FINISH	HOT DIP GALVANIZED
CUSTOMER	FORESTSIDE ESTATES INC
PROJECT	66-95 ATTAMAR DRIVE (BLDG. C)
LOCATION	BRAMPTON, ONTARIO
DETAIL	EXTERIOR GALVANIZED EXHAUST SHAFT GRATING
DRAWN BY	BL
CHECKED BY	SCALE AS NOTED
DATE	MAY 19/2021
DRAWING NO.	21-000C-MS1

EXTERIOR GALVANIZED AIRSHAFT GRATING FOR BUILDING 'A'

FINISH	HOT DIP GALVANIZED		
CUSTOMER	FORESTSIDE ESTATES INC		
PROJECT	GG-95 ATTMAR DRIVE (BLDG. A)		
LOCATION	BRAMPTON, ONTARIO		
DETAIL	EXTERIOR GALVANIZED AIR SHAFT GRATING		
DRAWN BY	BL	CHECKED BY	DRAWING NO.
DATE	MAY 19/2021	SCALE	A5 NOTED
			21-000A-M51

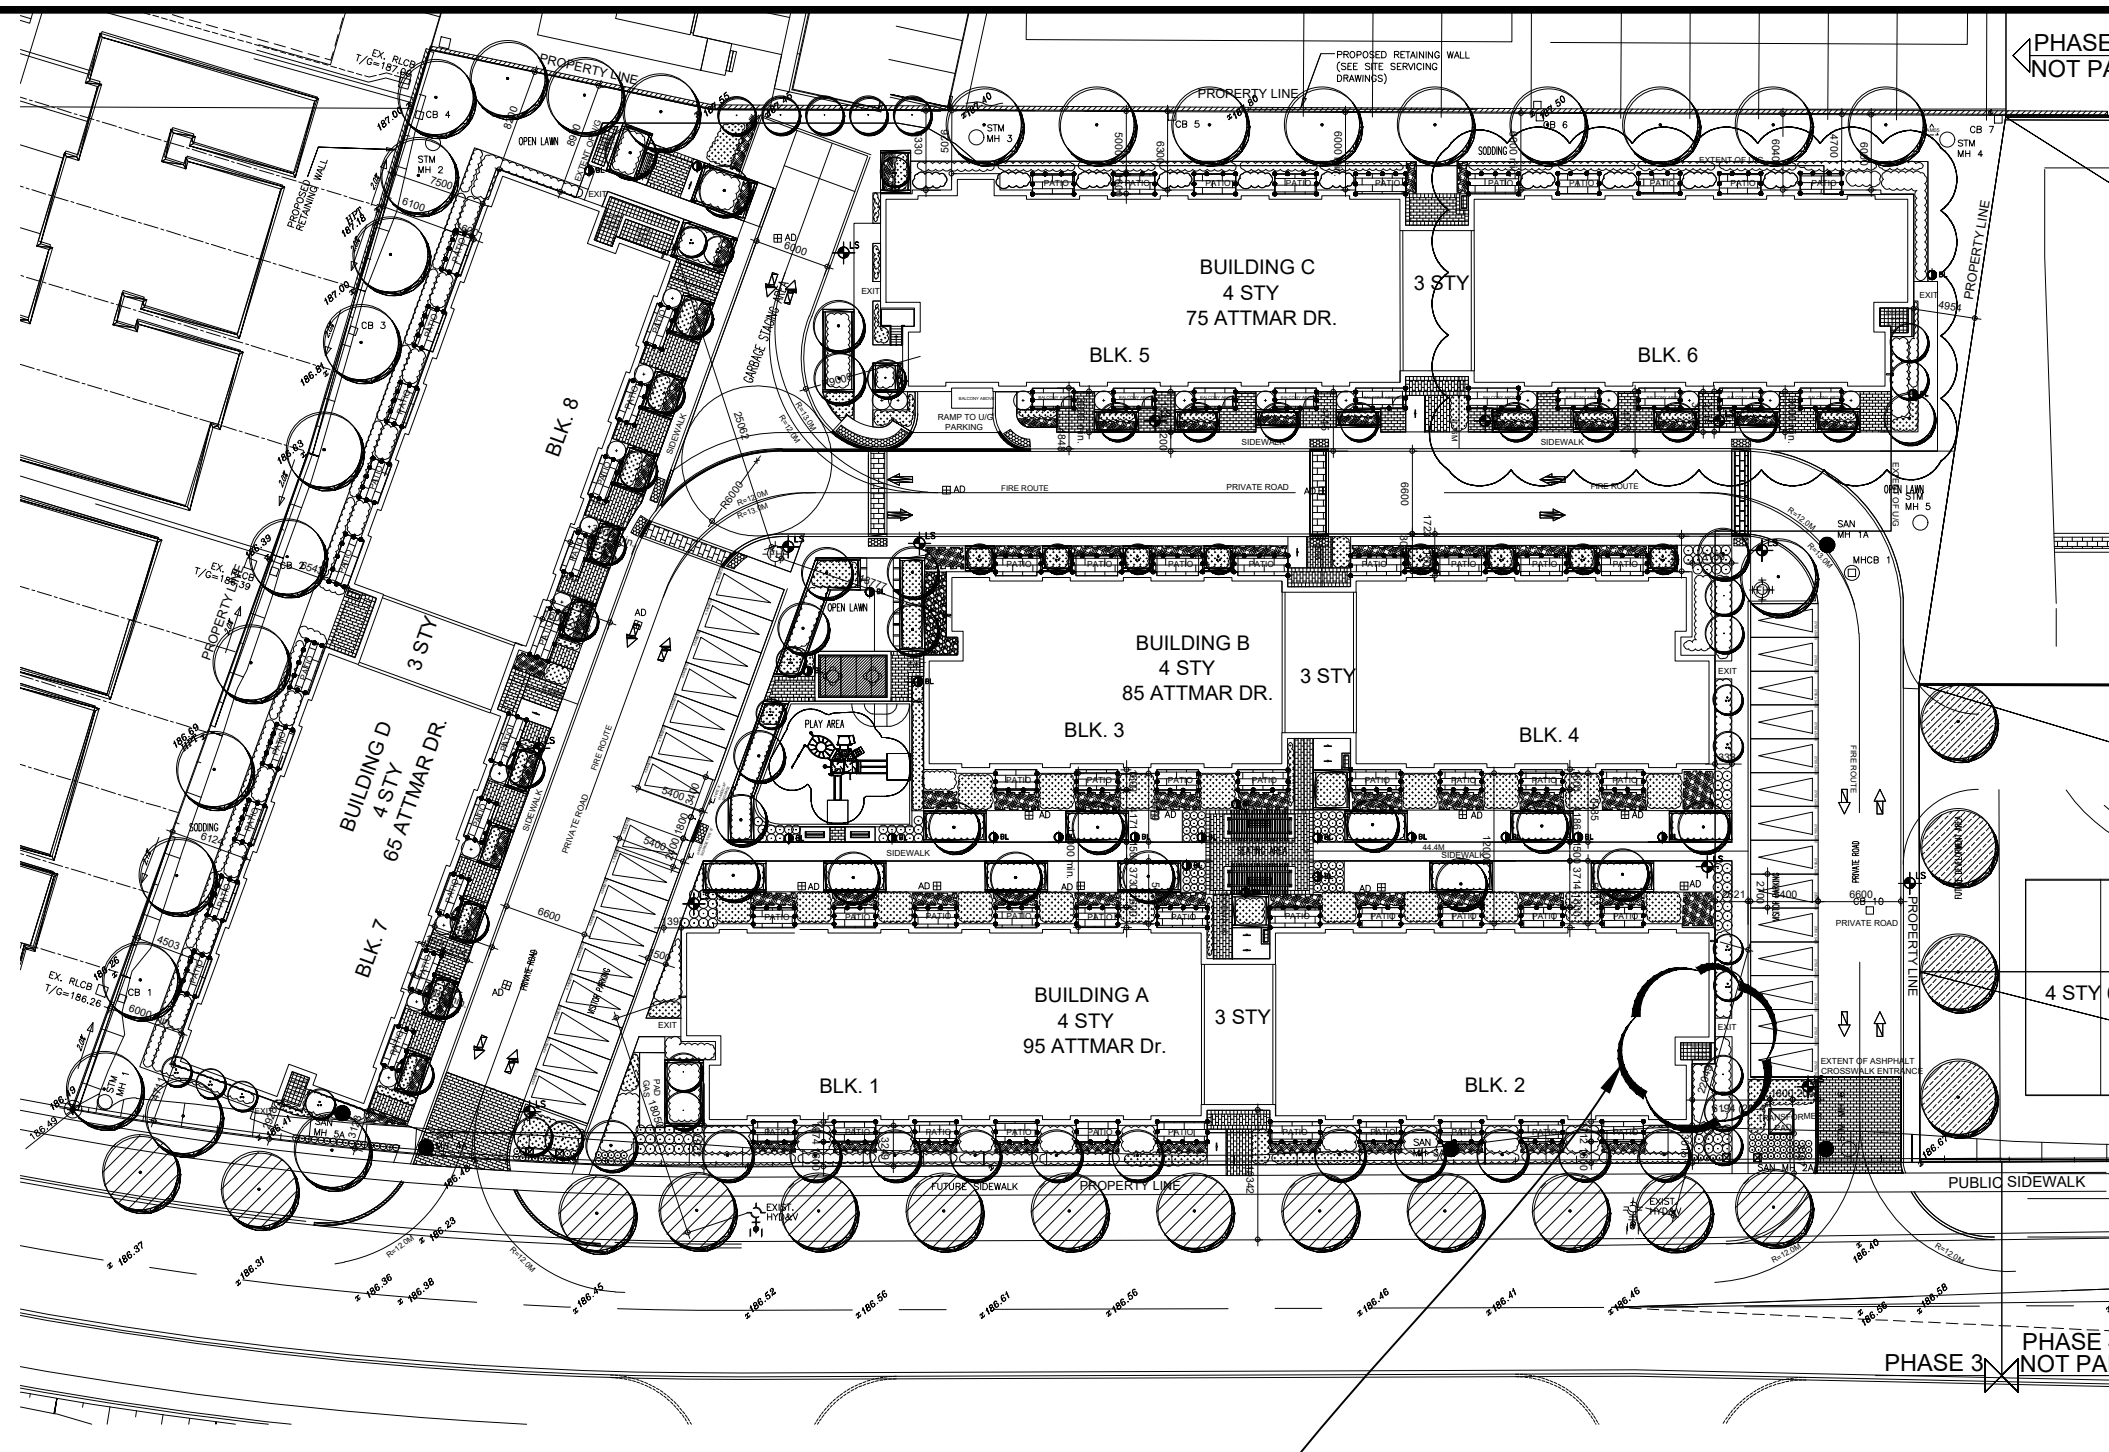
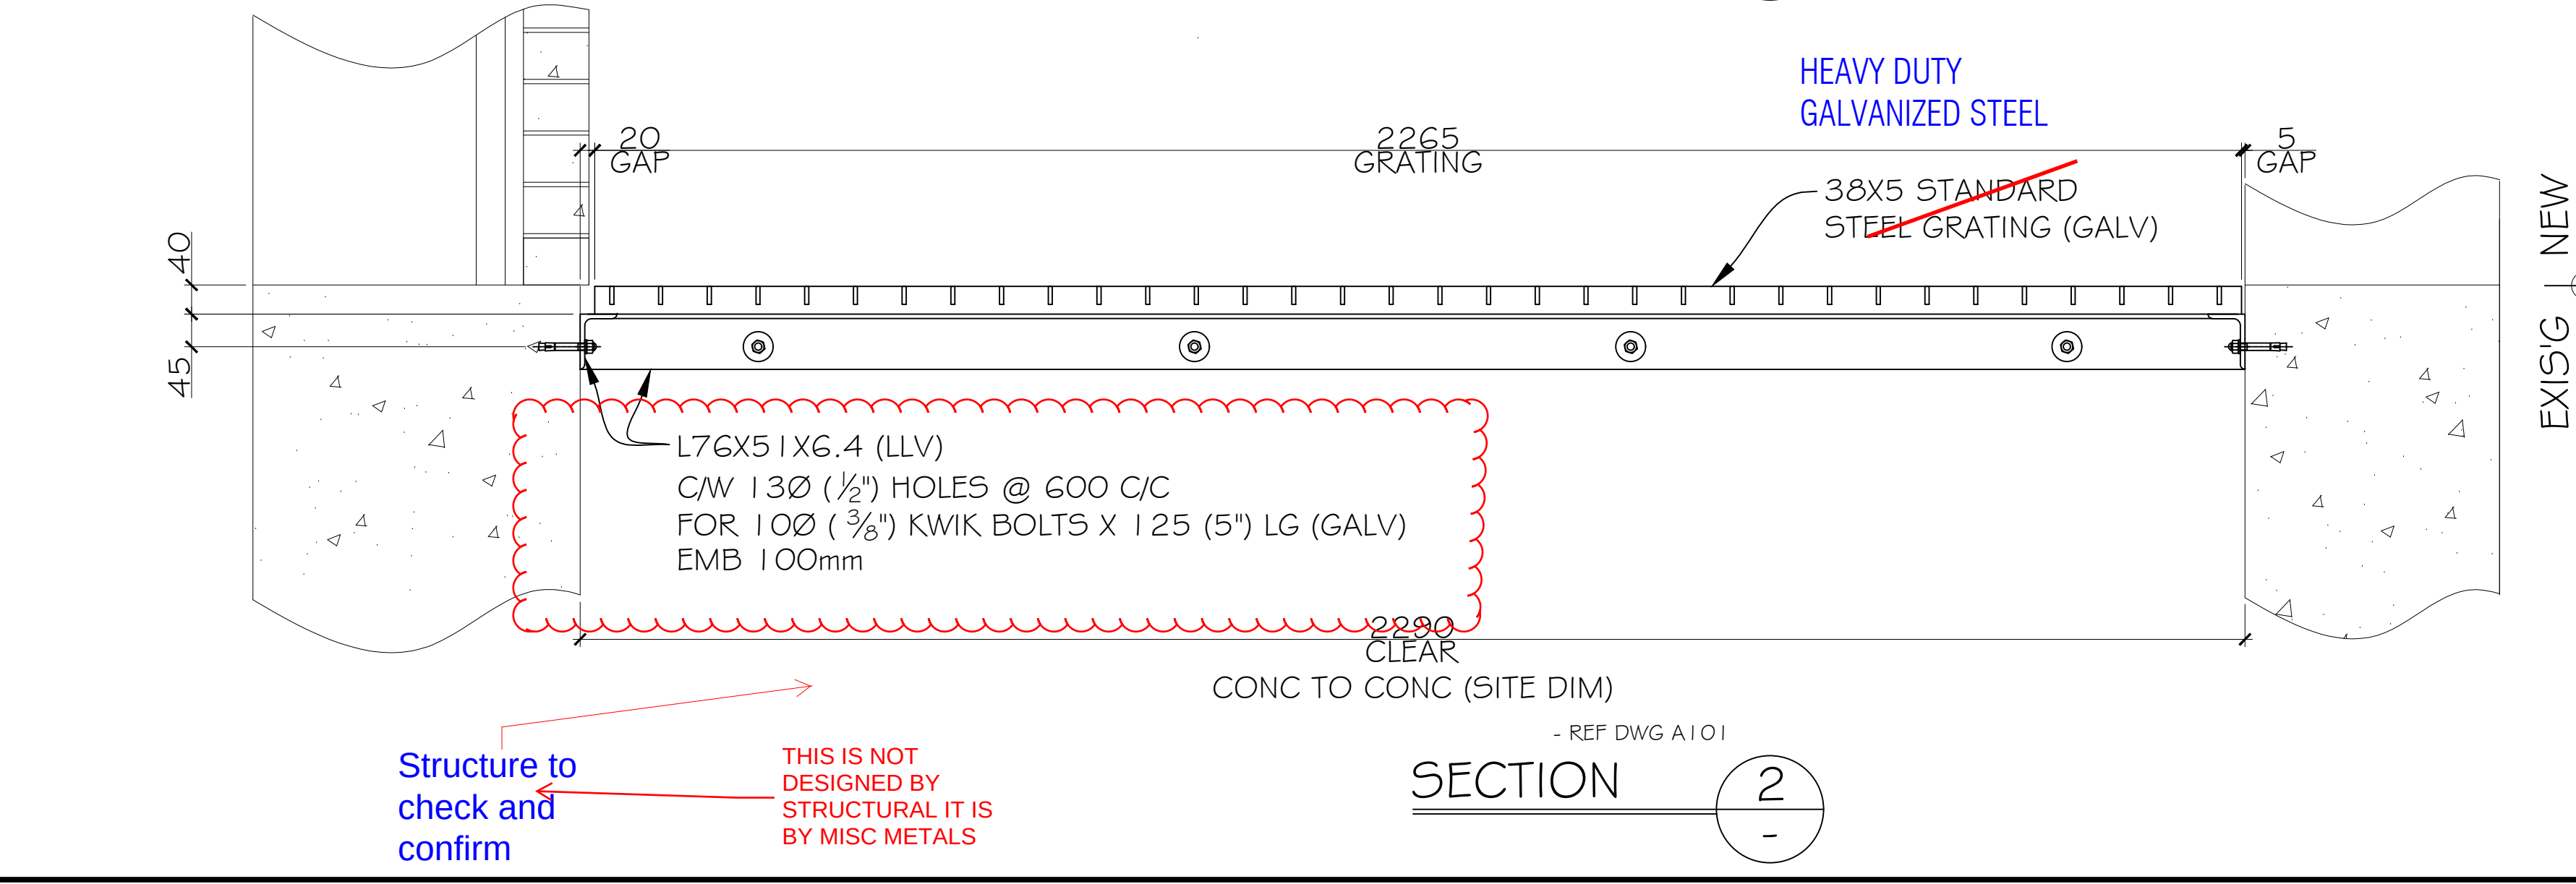
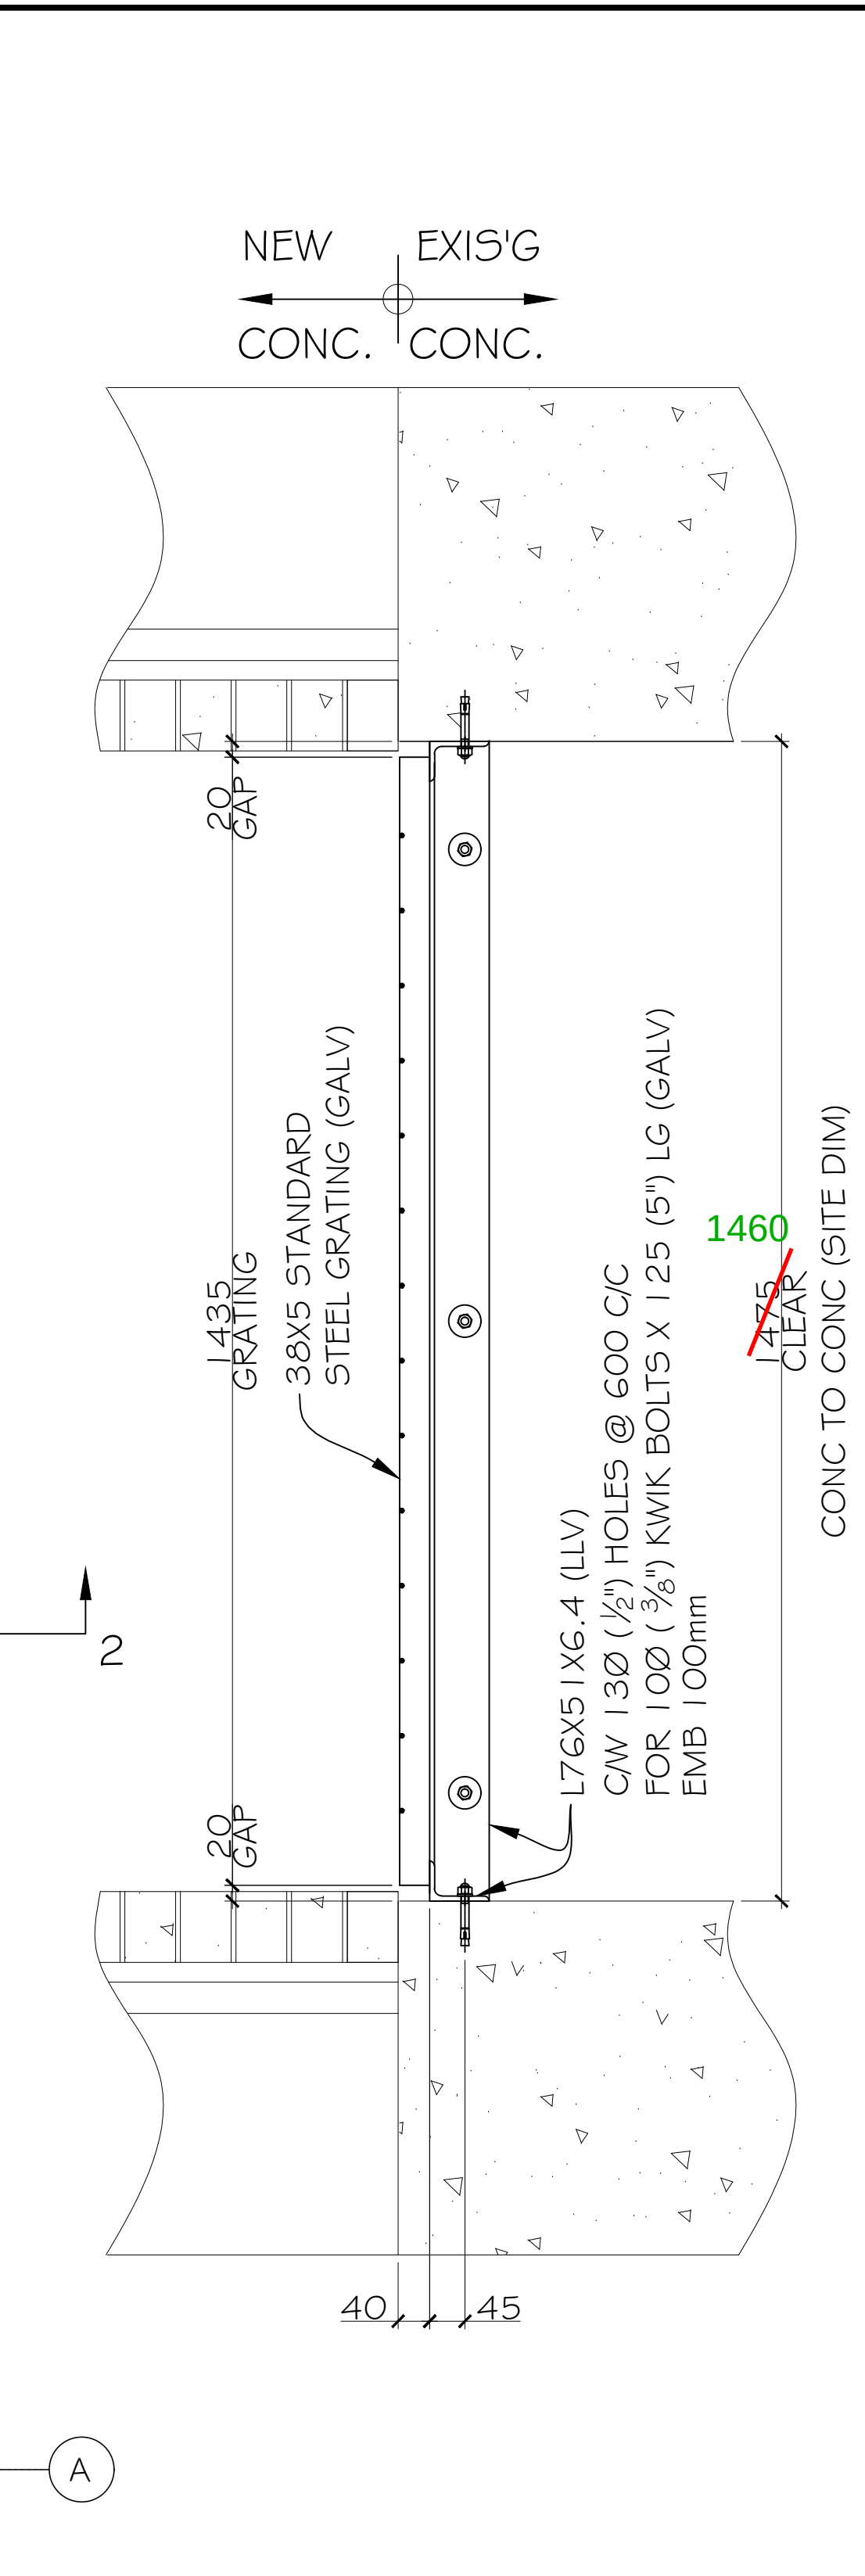
PROVIDE PENG STAMP

CONFIRM IF IT NEEDS TO BE DESIGNED FOR HEAVY TRUCK LOADING

G+C:
all beams dimensions must be checked by Structure, in terms of size and load.
